SAKURA EAST PRO JZ23-41

JZ23-41 SAKURA EAST PRO PLAN WITH REZONING 18.743

Public hearing at the request of Sakura Novi LLC for Planning Commission's recommendation to City Council for a Zoning Map Amendment from Light Industrial to Town Center One with a Planned Rezoning Overlay. The subject site is approximately 3.5-acres and is located south of Eleven Mile Road, west of Meadowbrook Road (Section 23). The applicant is proposing to develop a 45-unit multiple-family townhome development.

REQUIRED ACTION

DRAWING TITLE
PRELIMINARY SITE PLAN

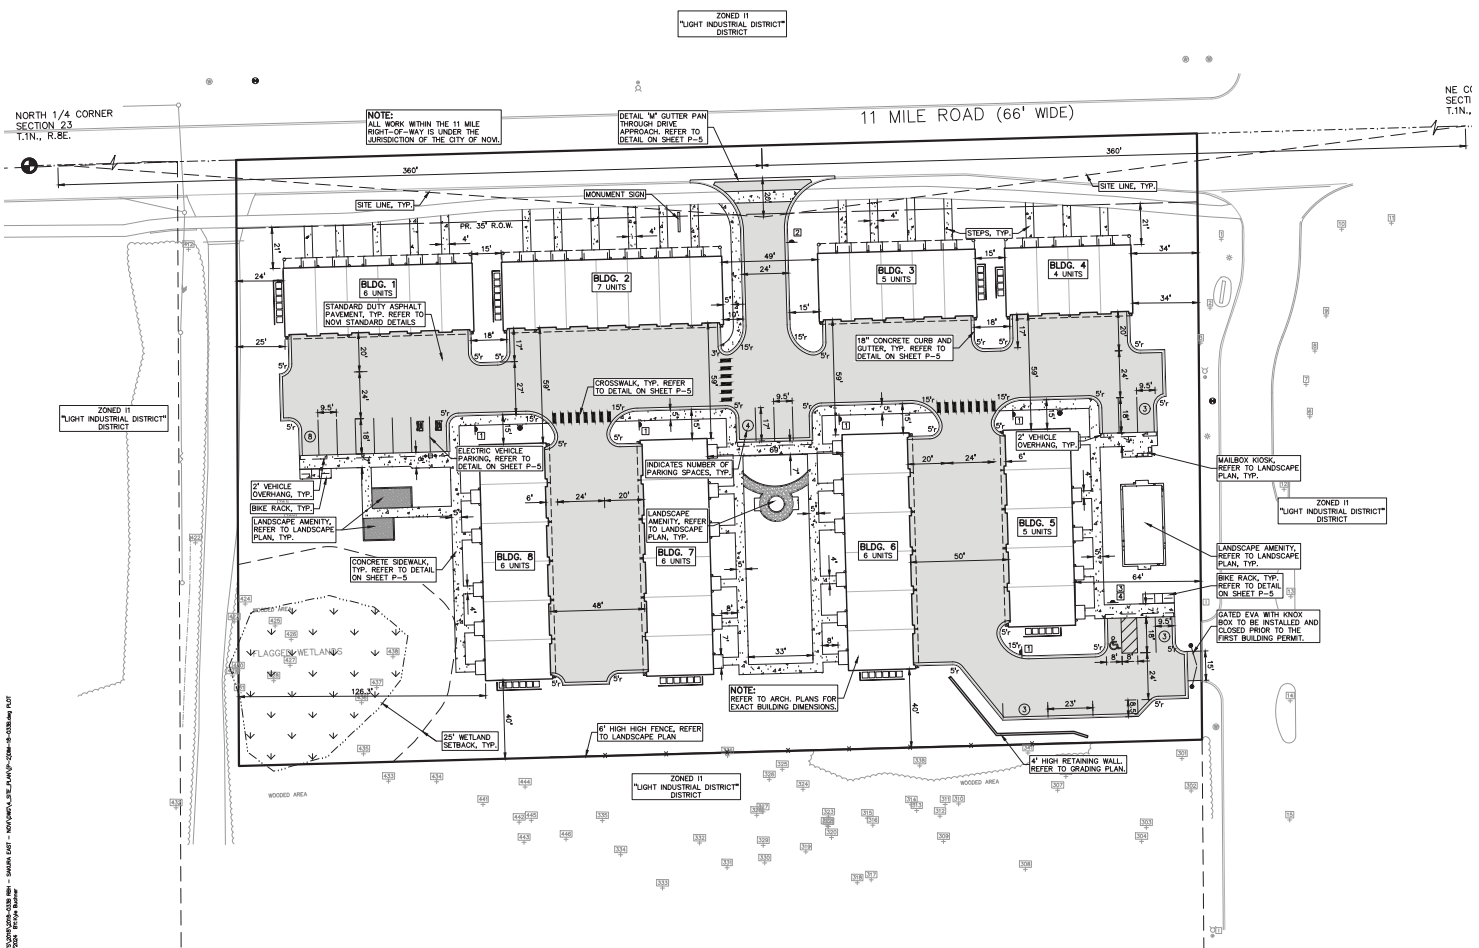
- a. An in-depth explanation of the need for a Wetland and Watercourse Setback can be found on page 3-67 of the [City of Novi Zoning Ordinance](#).
 - b. No impacts are proposed to the on-site Wetland. However, impacts appear to be proposed to the 25-foot Wetland Setback. Sheet P-2 shows a small portion of concrete sidewalk will be

Figure 1: Current Zoning

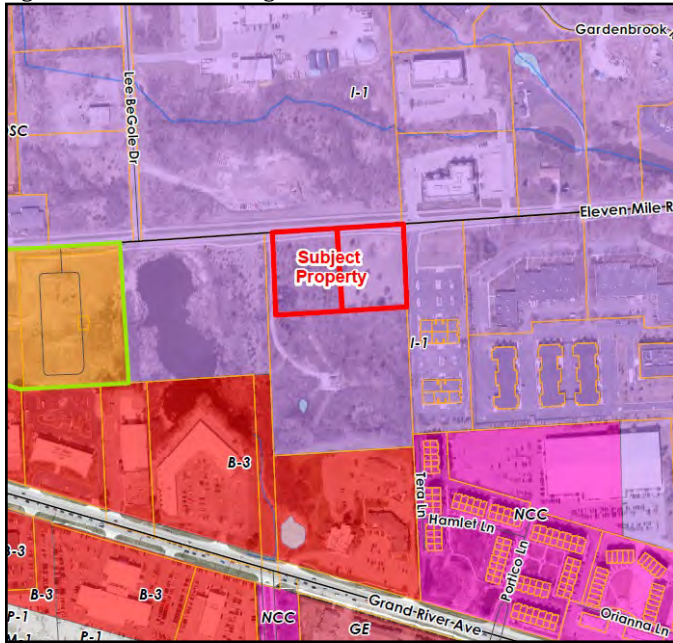
To the east is an area zoned I-1 Light Industrial. There is an office complex there with two existing buildings, with a third building approved to be constructed. There is no firm timeline on when that building would be constructed. This area is planned to remain Light Industrial use in the City's Master Plan. If residential uses are located adjacent to the property, the uses permitted in the I-1 district would be severely restricted compared to the list of uses that could otherwise be permitted. In addition, there is no berm separating the properties, as is required when non-residential uses are adjacent to residential uses. It would be the applicant's responsibility to provide the required berm and screening on the parcel to be developed with residential uses. No such berm is currently proposed

The proposed residential use would be surrounded on all sides by industrially zoned properties. There is no obvious connection to the larger Sakura Novi development, except for the sidewalk along 11 Mile Road and identical townhouse product type to be developed. The lack of contiguity between
